RFQ NUMBER
DCH08105

LINE	QUANTITY	UOP	CAT NO	ITEM NUMBER	UNIT PRICE	AMOUNT
----- ADDENDUM NO. 2 ----- THIS ADDENDUM IS ISSUED TO ADDRESS QUESTIONS/CONCERNS RAISED DURING THE MANDATORY PRE-BID CONFERENCE OF 02/14/2008 AND THE QUESTION SUBMISSION DEADLINE OF 02/15/2008. ATTACHMENTS: QUESTIONS AND RESPONSES BID OPENING DATE REMAINS: 03/27/2008 ----- END OF ADDENDUM NO. 2 -----

Project: West Virginia Museum of Culture and History
Charleston, WV

Subject: Specialty Contractor Questions

1 SODA SHOP FLOOR TILE PATTERN
 SCALE: 1/2" = 1'-0"

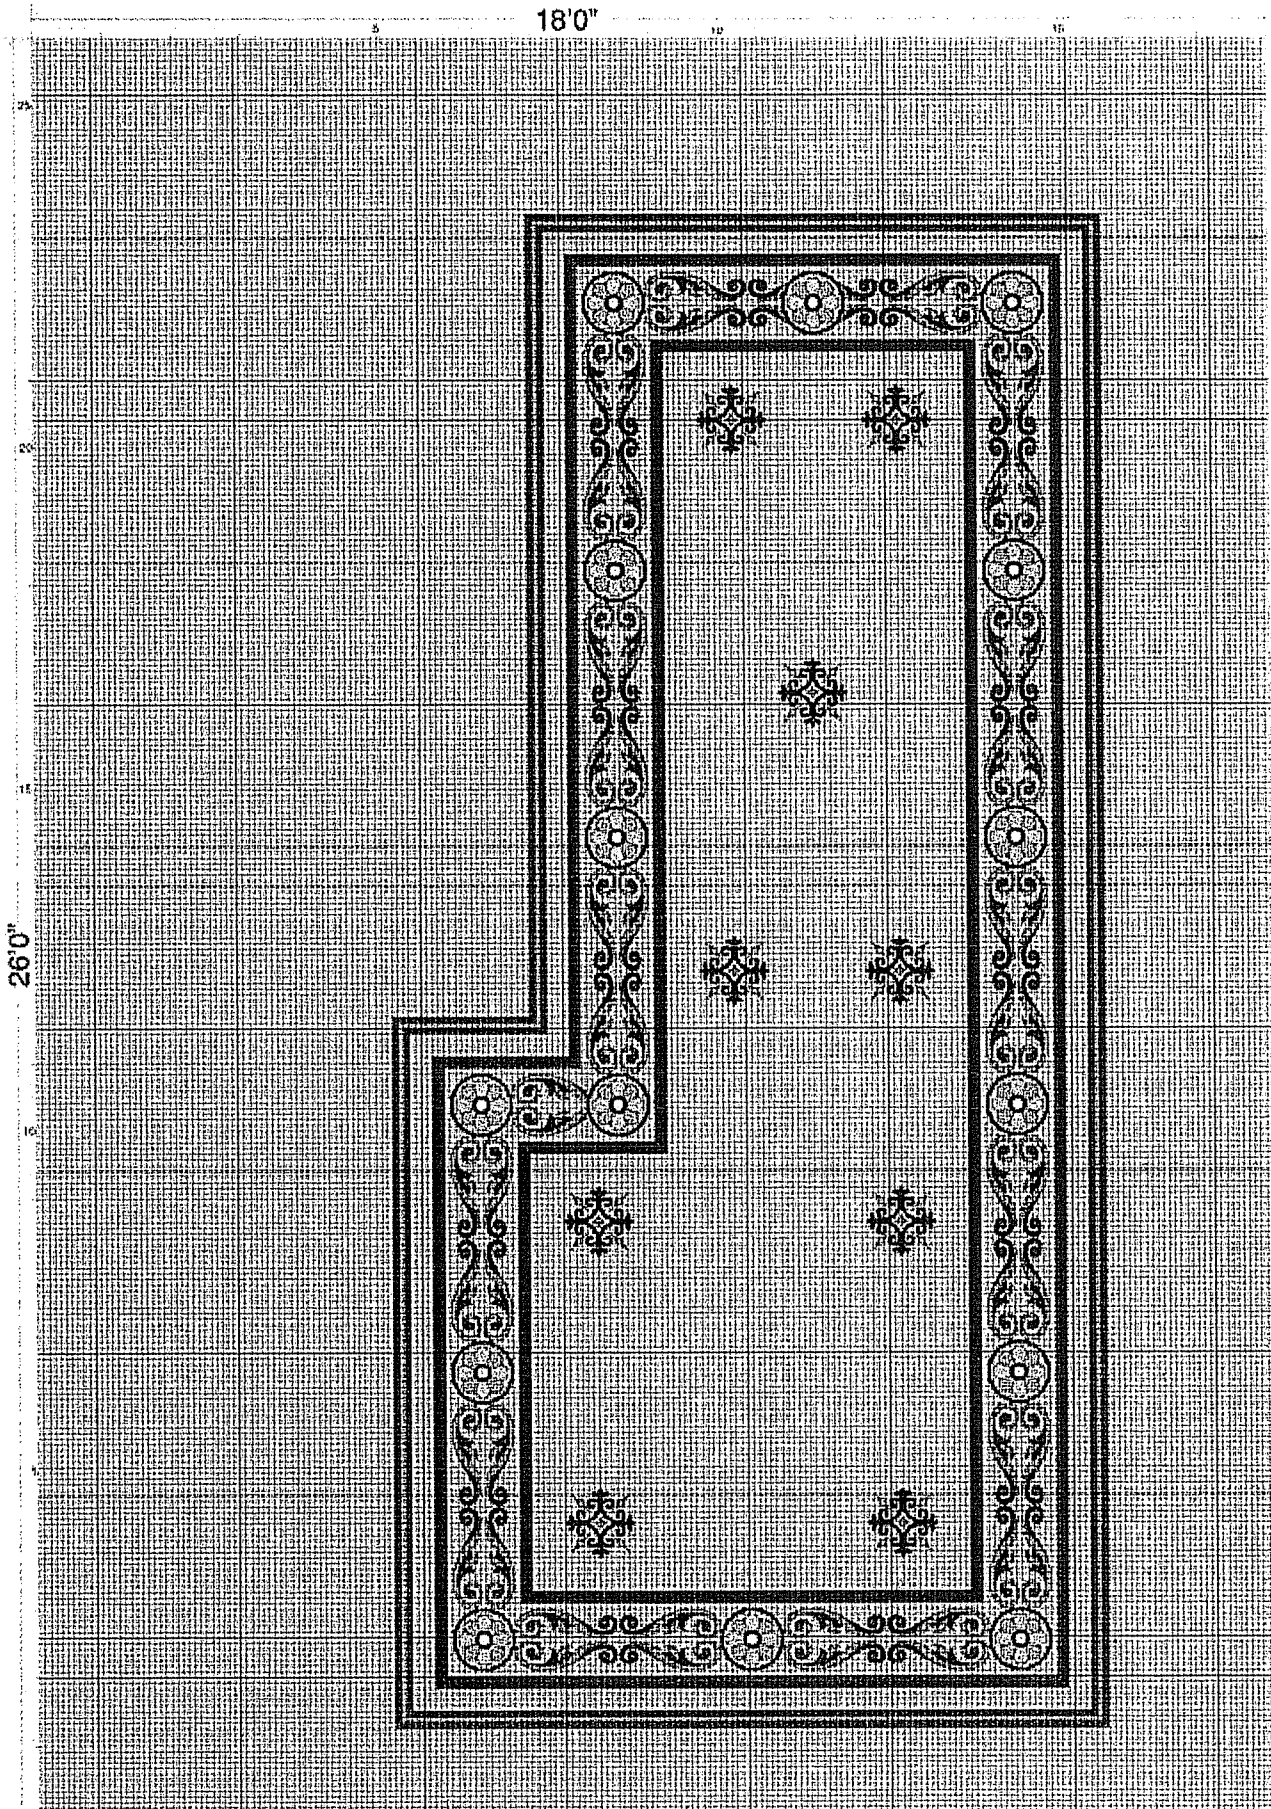
15. Other than the scenic floor finishes listed on the drawing sheet D0.03, will all other flooring be provided and installed by the general contractor?

The Specialty Contractor (SC) is to provide all of the flooring identified on sheet D-0.03. The SC is also to finish all flooring identified in the Room Finish Schedule Legend on sheet A-5.01 as finished by scenic vendor. The SC is also to provide **all** flooring identified in the Room Finish Schedule and Legend on sheet A-5.01 as types BP-1, BP-2, CON-1, CON-2, CT-1, CT-2, SL-1, SL-2, WF-3, WF-5, WF-6, WF-7, WF-8, WF-9, and WF-10 per the attached.

STARFIELD - QUANTITY

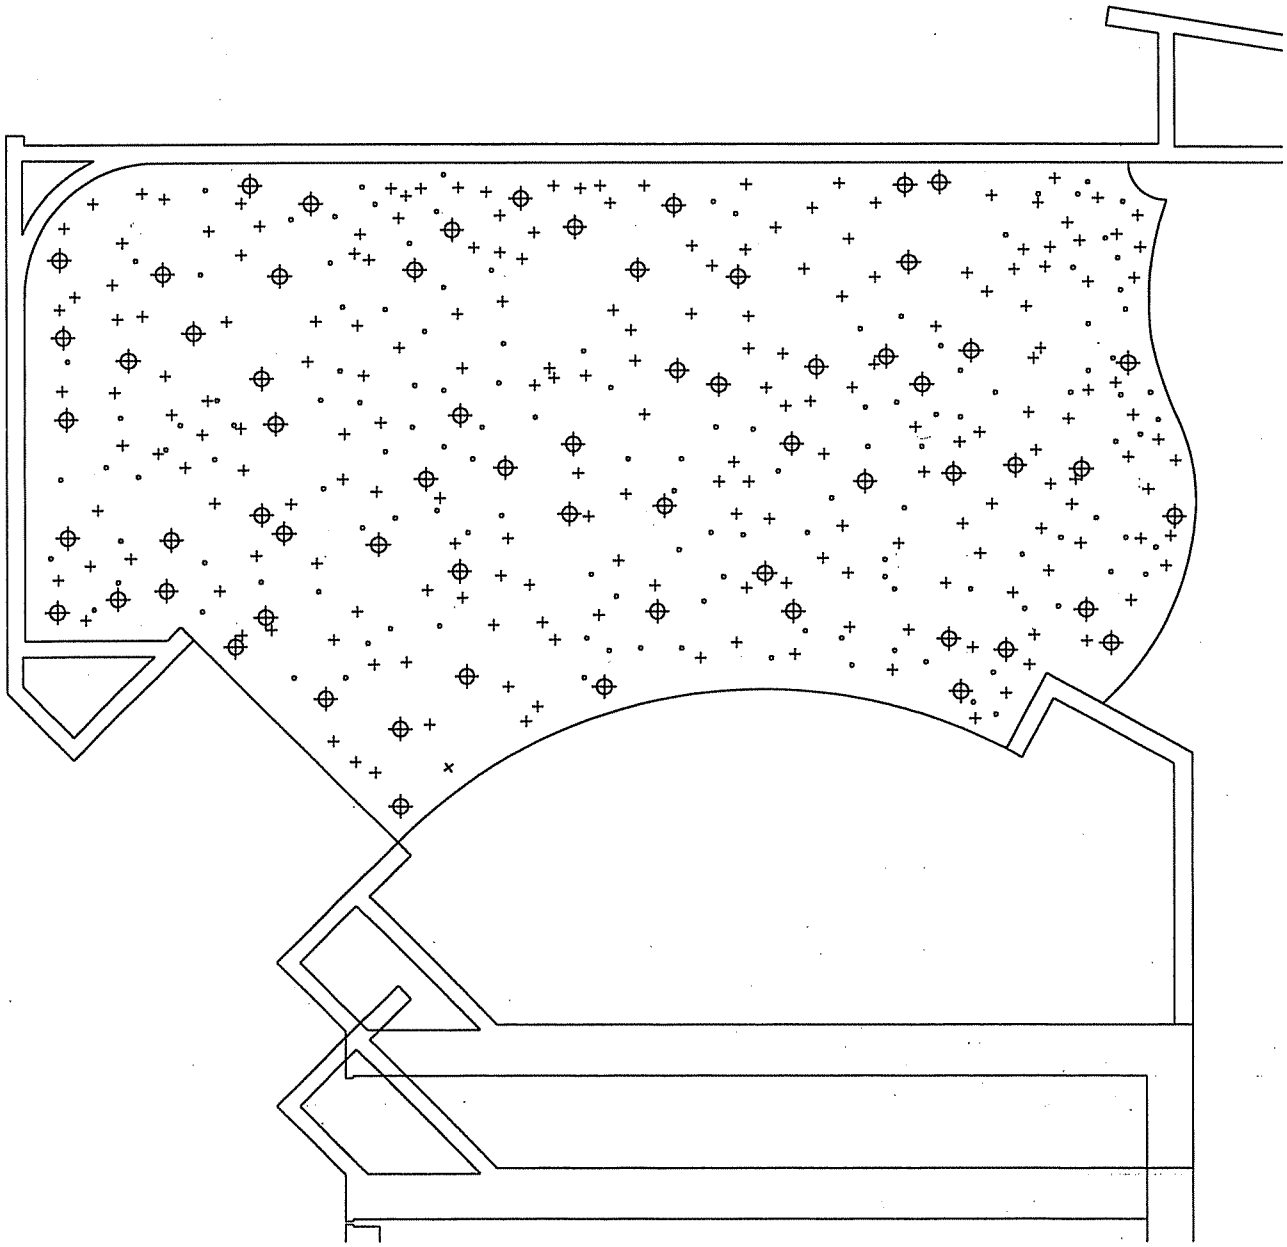
22. Please verify that the general contractor will be providing the fiber optics including the illuminators, fibers and fixtures. Verify that specialty contractor is responsible for drilling and placement as well as the installation of the star field?

The general contractor will provide the fiber optics including the illuminators, fibers and fixtures. The specialty contractor is responsible for drilling and placement as well as the installation of the star fields in Showpath #301 and Showpath #509.

2" LIGHTBOX ON WALL WITH
 BACKLIT MURAL (D-P-05-07)

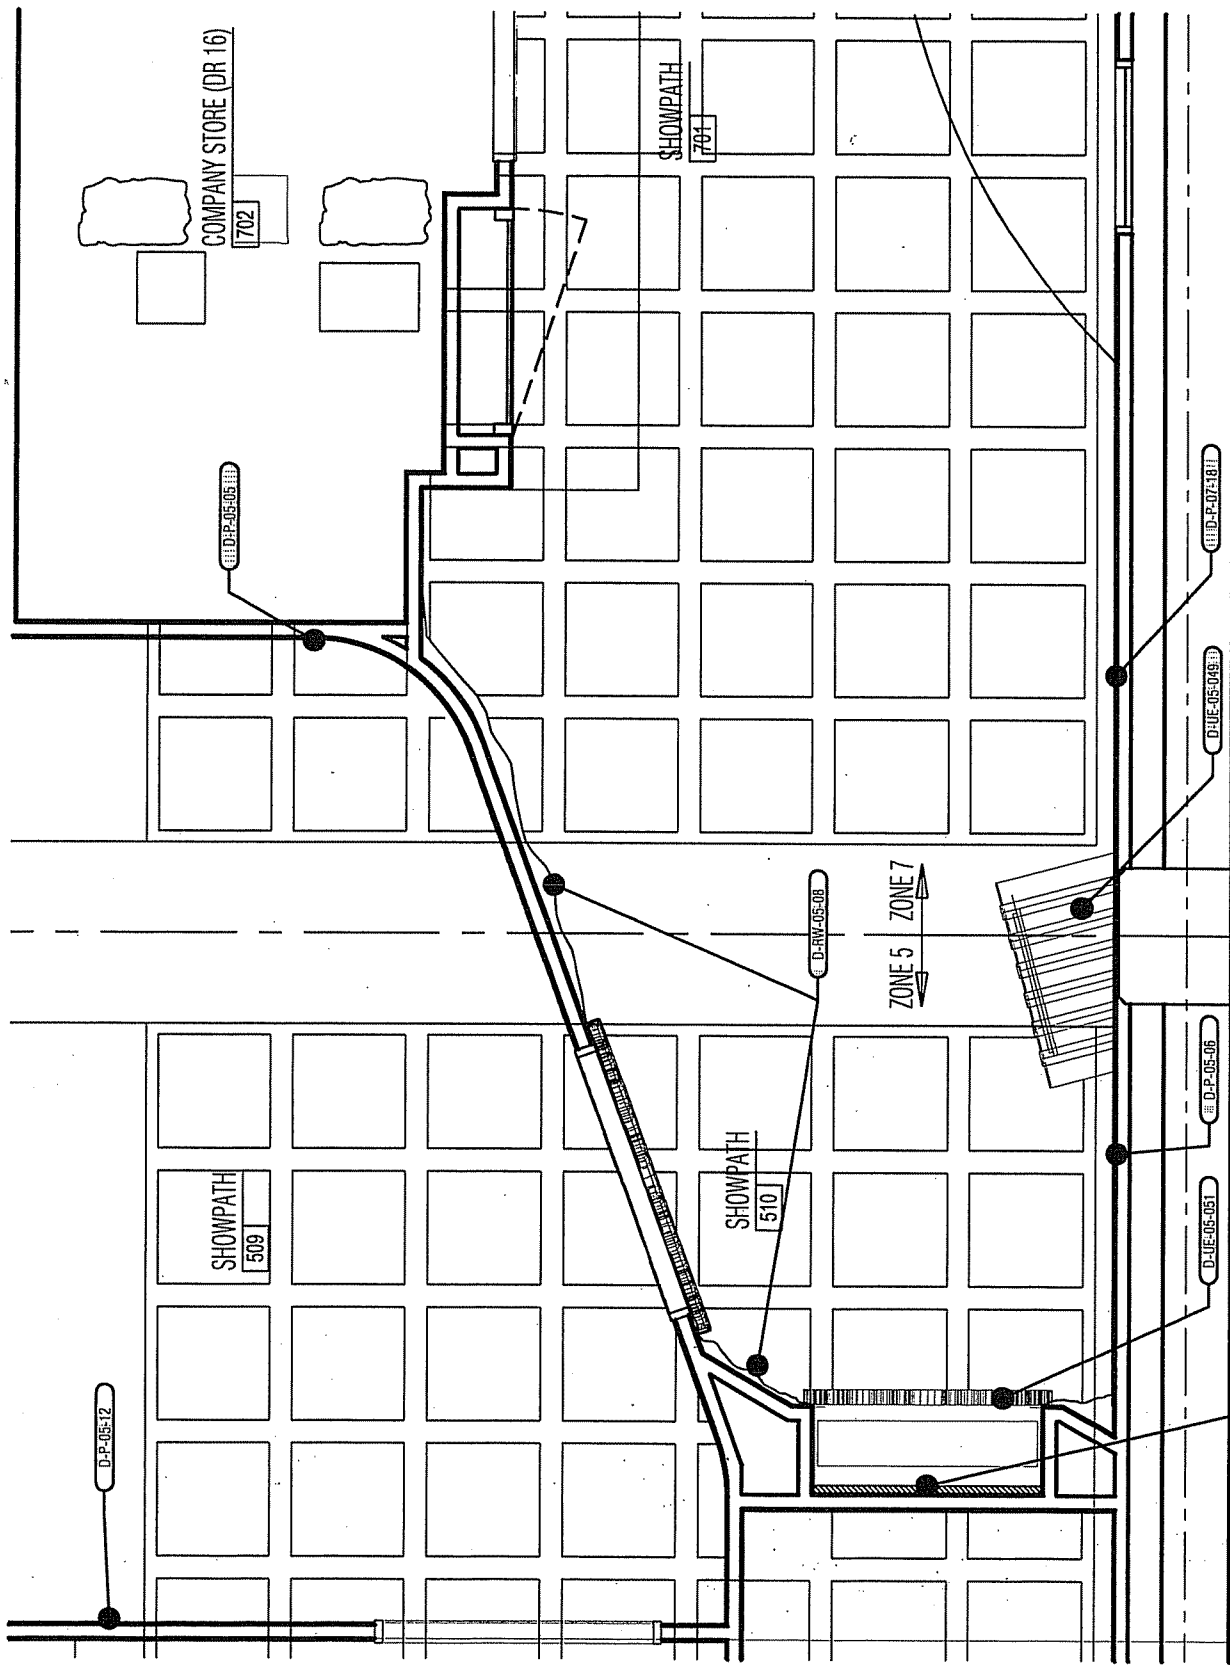
14. The Dimensions for four scenic murals, D-P-05-07, D-P-07-06, D-P-07-12 and D-P-08-12 cannot be located in the drawing package. Where can the dimensions for these murals be found?

- D-P-05-07: Mural size is 4’-3” W x 9’-5” H. Refer to supplemental drawing D5.520B.
- D-P-07-06: Mural size is 15’-6” W x 11’-9” H. Refer to supplemental drawing D5.771B.
- D-P-07-12: Mural size is 9’-8” W x 9’-9” H. Refer to supplemental drawing D5.781A.
- D-P-08-12: Mural size is 16’-0” W x 12’-0” H. Refer to supplemental drawing D5.803B.
